<p>PALOMAR ENERGY PROJECT (01-AFC-24) CEC STAFF DATA REQUEST NUMBER 64</p>	
<p>Technical Area: Traffic and Transportation</p>	<p>Response Date: April 8, 2002</p>

Figure 5.11-5
Existing Intersection Turning Movement Volumes
PALOMAR ENERGY PROJECT

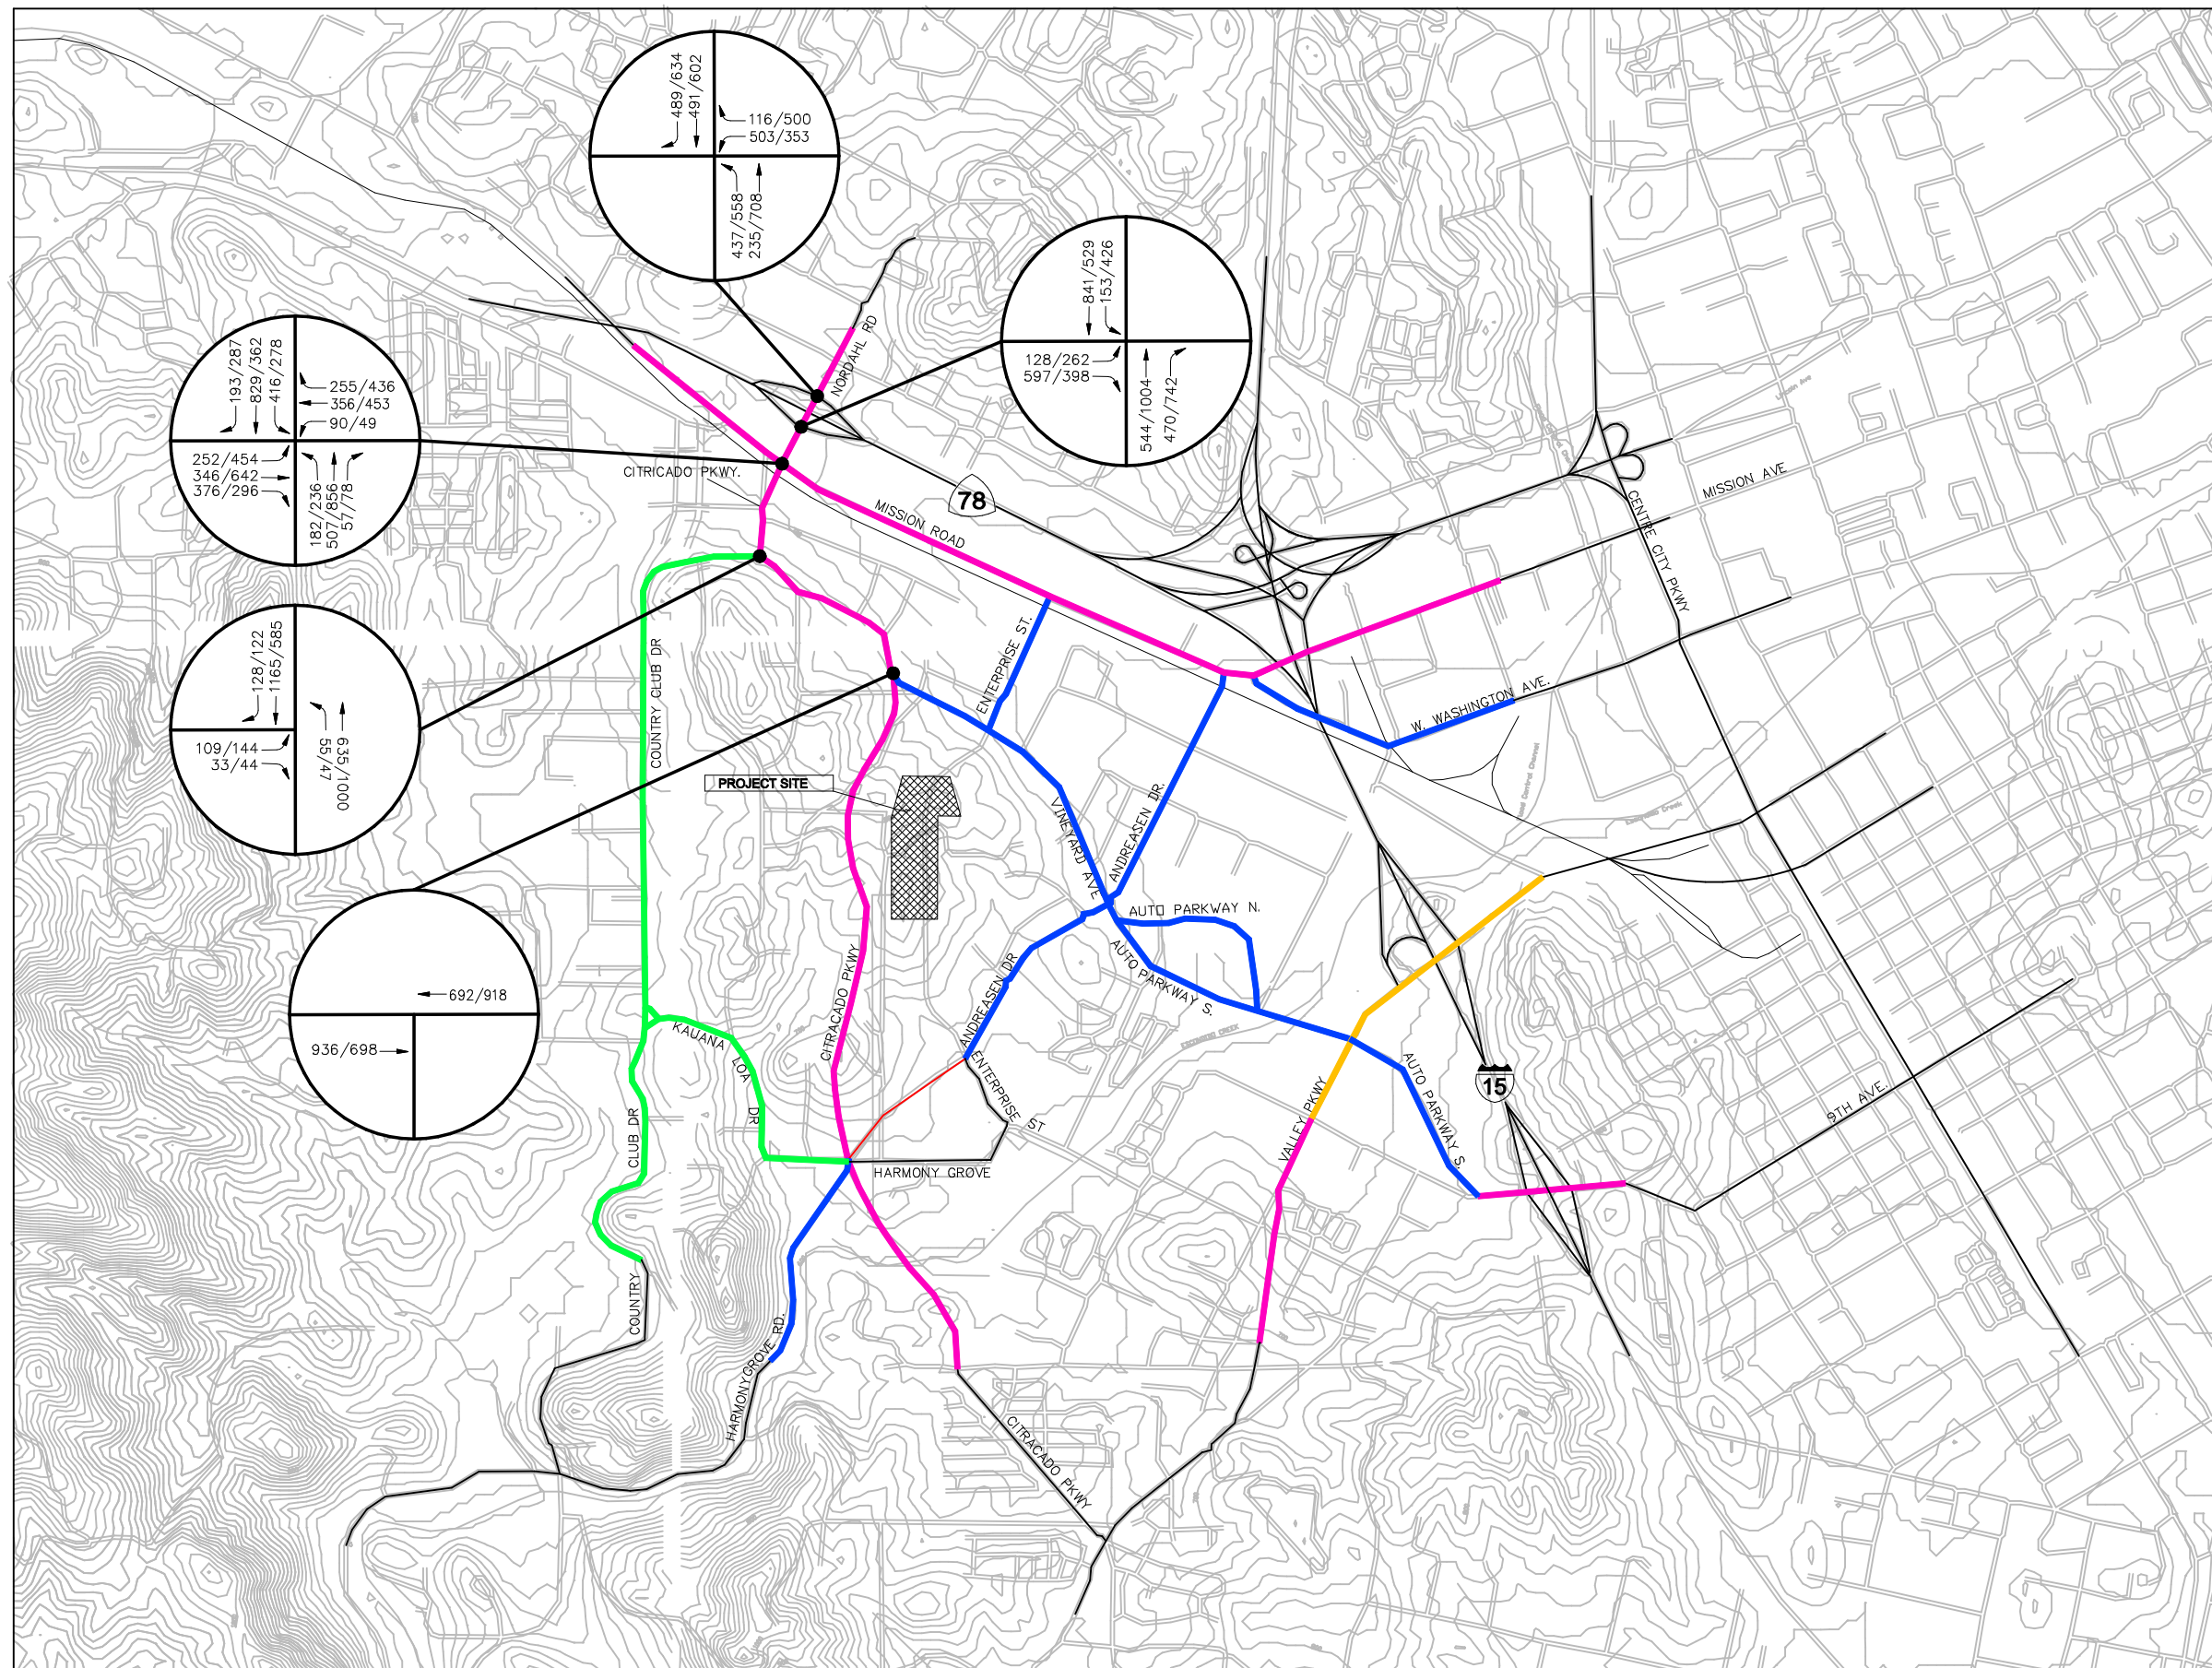
Please modify the depicted volumes at the Vineyard Avenue/Country Club Drive intersection to show the correct orientation of approach volumes.

See revised Figure 5.11-5 on the following page.
